■METER

1. General

01NBE144Y

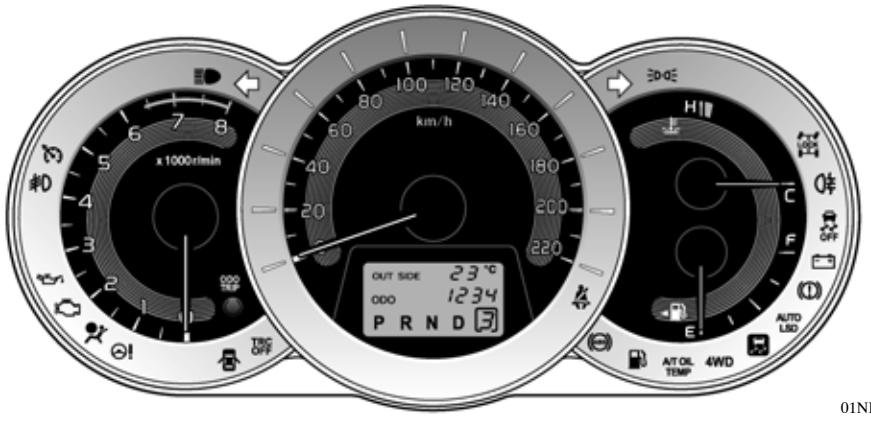
- The design of the combination meter has been changed.
- The indication size of the shift position indicator has been increased.
- A parking brake unreleased warning function, which sounds the buzzer if the vehicle is driven with the parking brake applied, has been added.
- The following indicator lights have been changed:
